16092A-02

S E R V I C E N O T E

16092A Spring Clip Fixture

This service note provides the updated part numbers and figures for both RoHS and non-RoHS 16092A Spring Clip Fixture

Figure 1-1

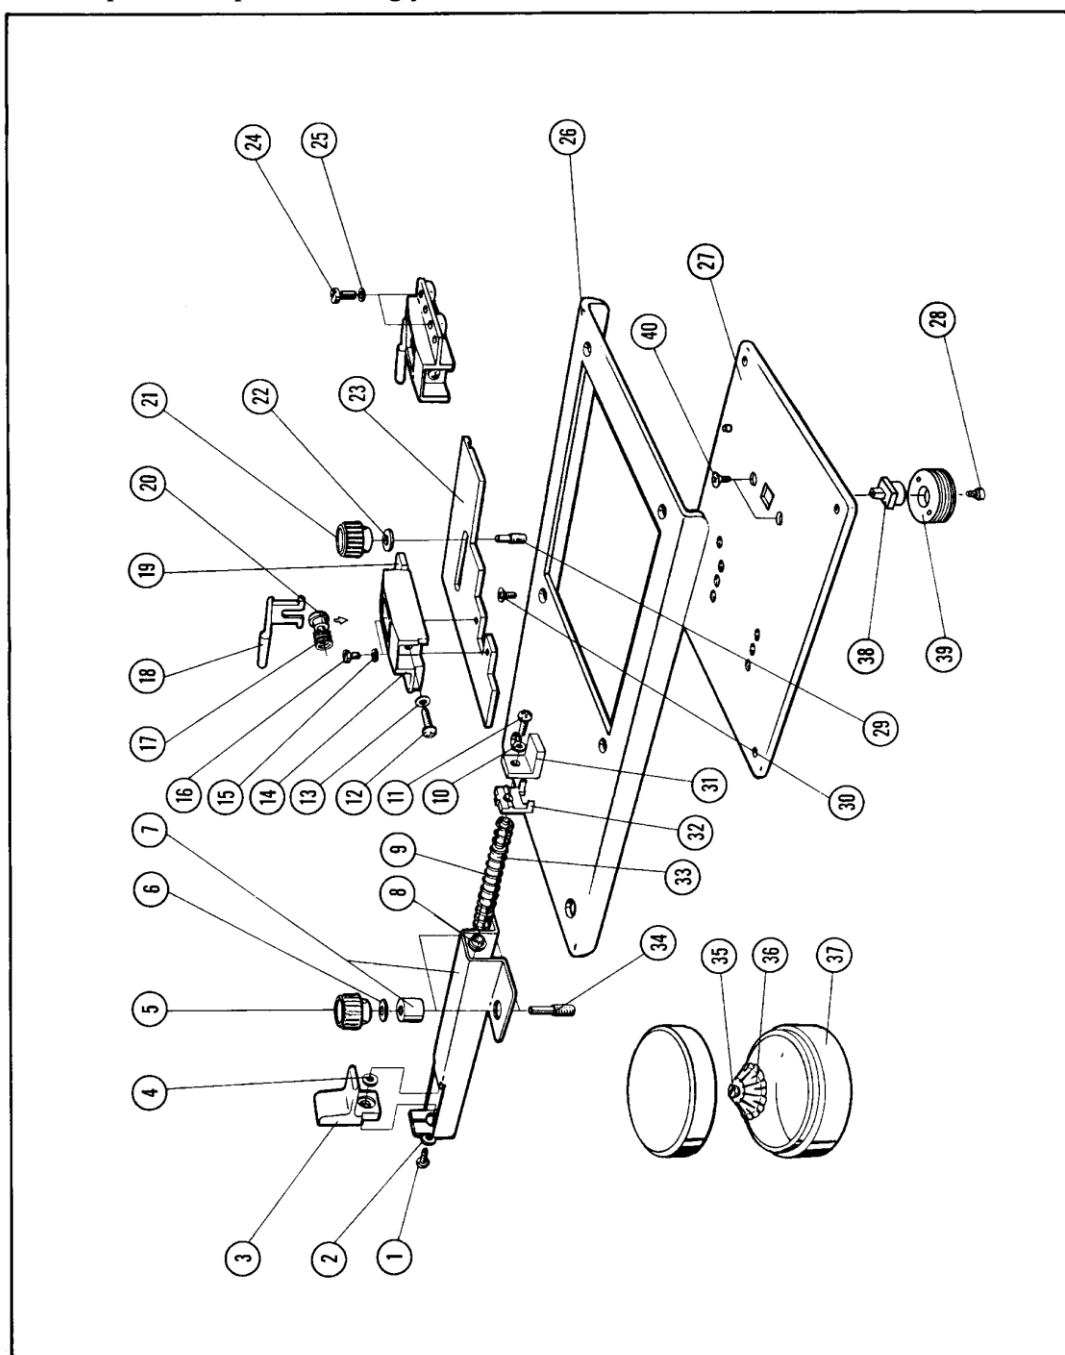
Shown are the supported parts and their respective RoHS compliant replacement support part. RoHS conversion involves with design and dimension change which result in the RoHS support part backward incompatible with non-RoHS 16092A. Special handling is needed while using the RoHS replacement part on non-RoHS 16092A. The original support part number is replaced by the respective "RoHS Compliant Replacement Part". Once the original support part is depleted, please proceed to obtain the RoHS compliant support part. Please refer to figure 1-1 and table 1-1 for the respective replacement part accordingly.

<*1> Replace all the associated parts marked with <*1> as they are mutually dependent.

<*2> Replace all the associated parts marked with <*2> as they are mutually dependent.

<*3> Replace all the associated parts marked with <*3> as they are mutually dependent.

Figure 1-2

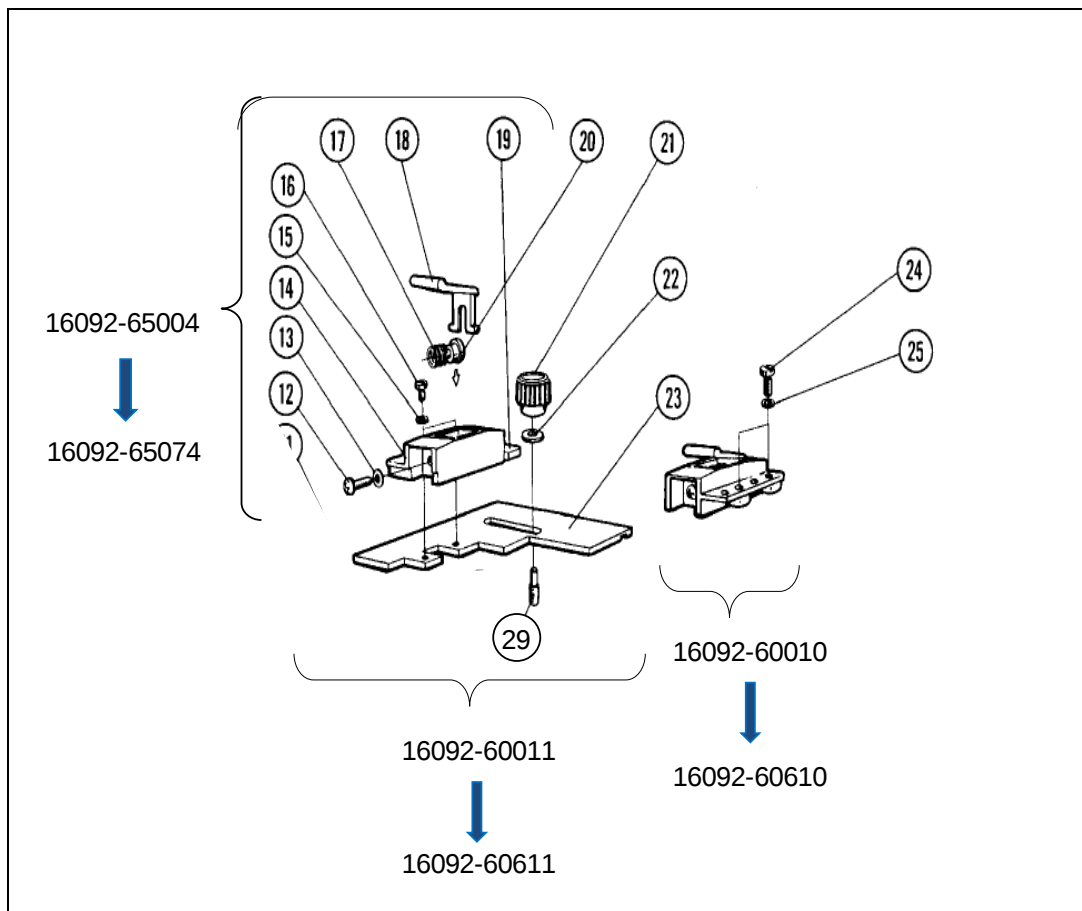
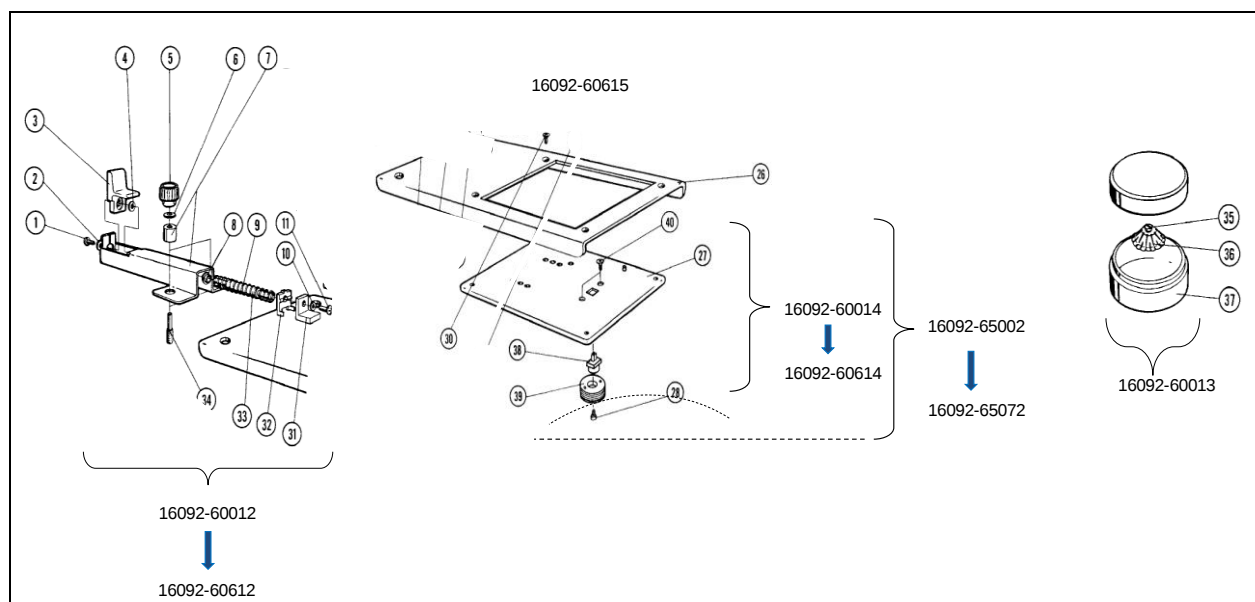
Shown in table 1-2 and figure 1-2, 1-3 are the sub-assemblies of 16092A.

Figure 2-1

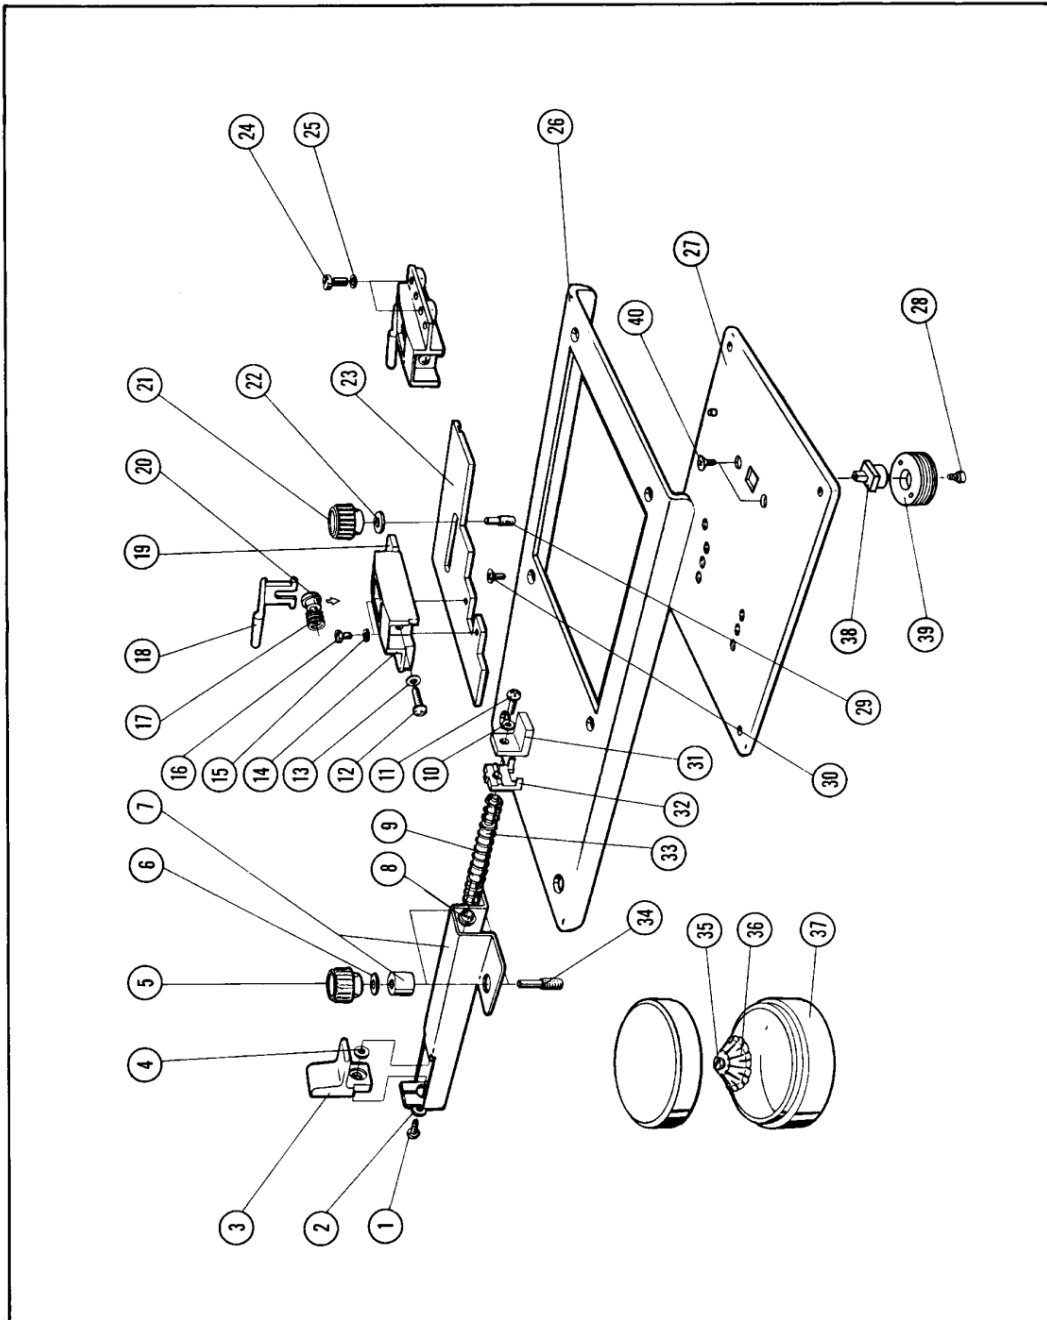
Shown are the support parts for RoHS compliance 16092A Spring Clip Fixture. All the listed items are changed at RoHS conversion. Due to limited availability of RoHS compliance station and technical difficulties in RoHS soldering, only parts and support level that do not require RoHS soldering are supported. Shown are the supported RoHS compliance parts for RoHS 16092A Spring Clip Fixture.

Shown in table 2-1 and figure 2-1 are the respective support parts for RoHS compliance 16092A unit.
